BEFORE INDEPENDENT HEARING COMMISSIONERS APPOINTED BY THE  
TASMAN DISTRICT COUNCIL

Application for resource consent by  
**Māpua Community Boat Ramp Trust**

STATEMENT OF EVIDENCE OF GARY NOEL STEVENSON  
ENGINEERING

Dated: 1 November 2024

#2> boat trailer - lightning 20031125 1027 75°

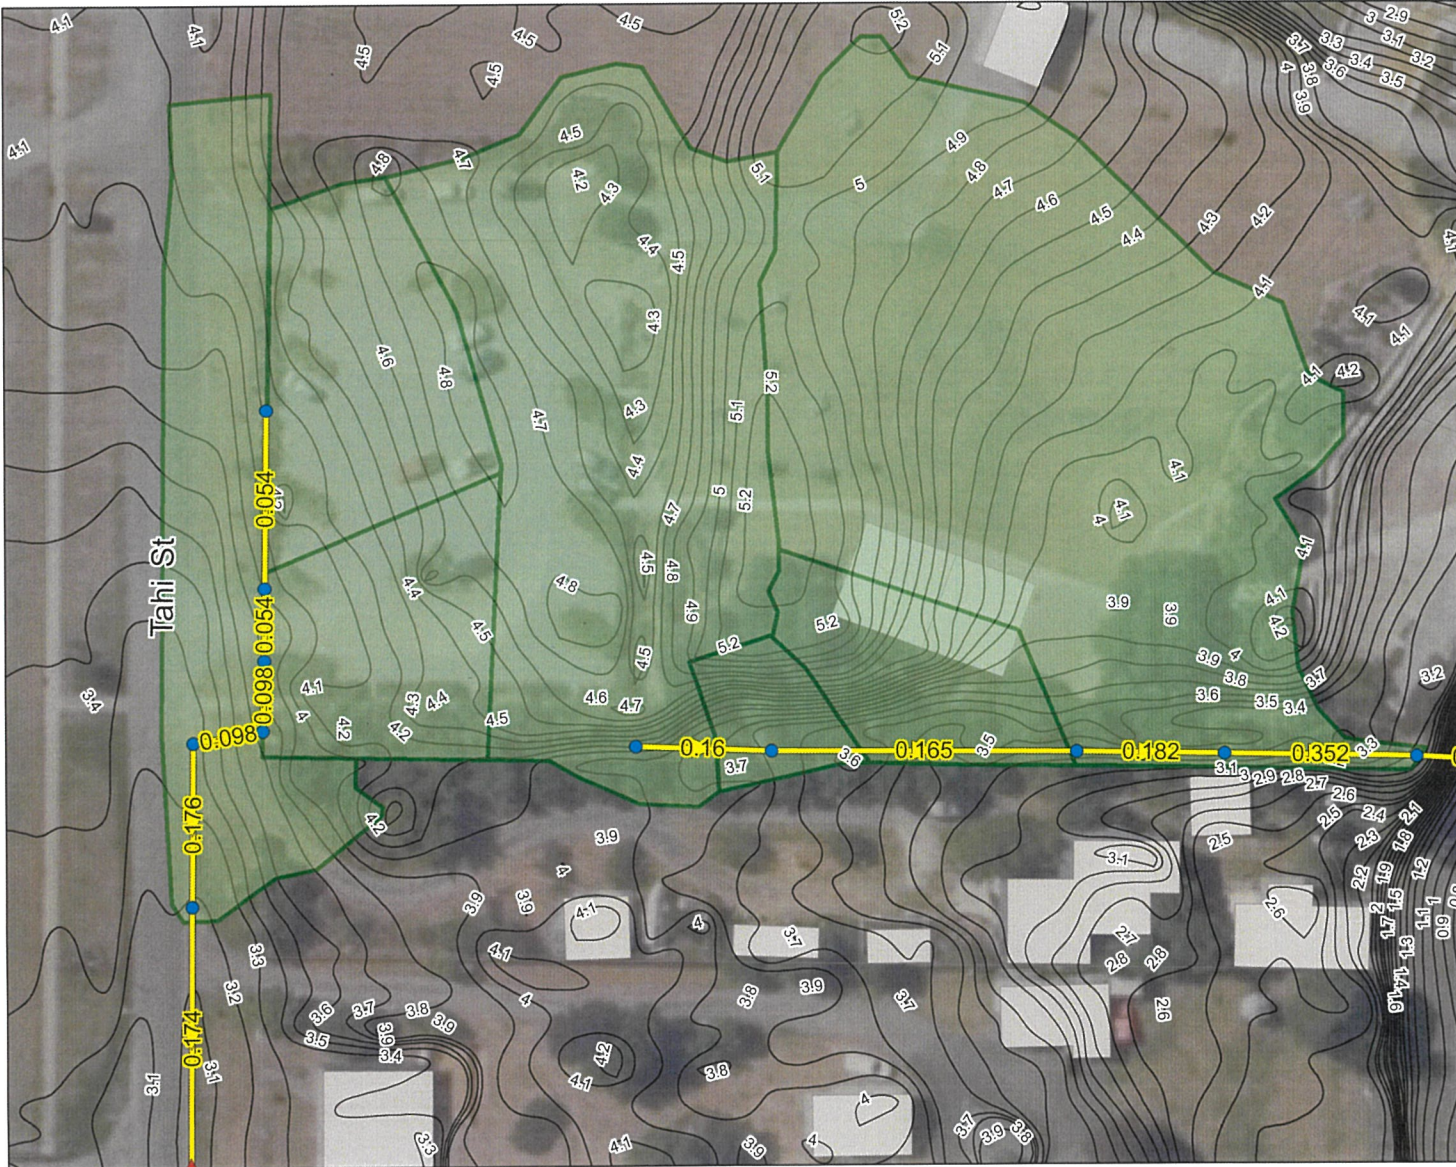
22. (S42, 14.11) Stantec raised concerns with swept paths of 10 parking spaces located in the western car park.

24. (s42, 14.23 & 14.24) Stantec have noted that tracking curves have not been provided for manoeuvring through the car park from the accessway barrier arm and on the ramp.

I comment: Annexed is a swept path analysis drawing that shows these parks can be utilised. I note that the parking is also provided for overflow parking and can be utilised for this purpose.

I comment: I annex tracking curves to show that this is achievable.
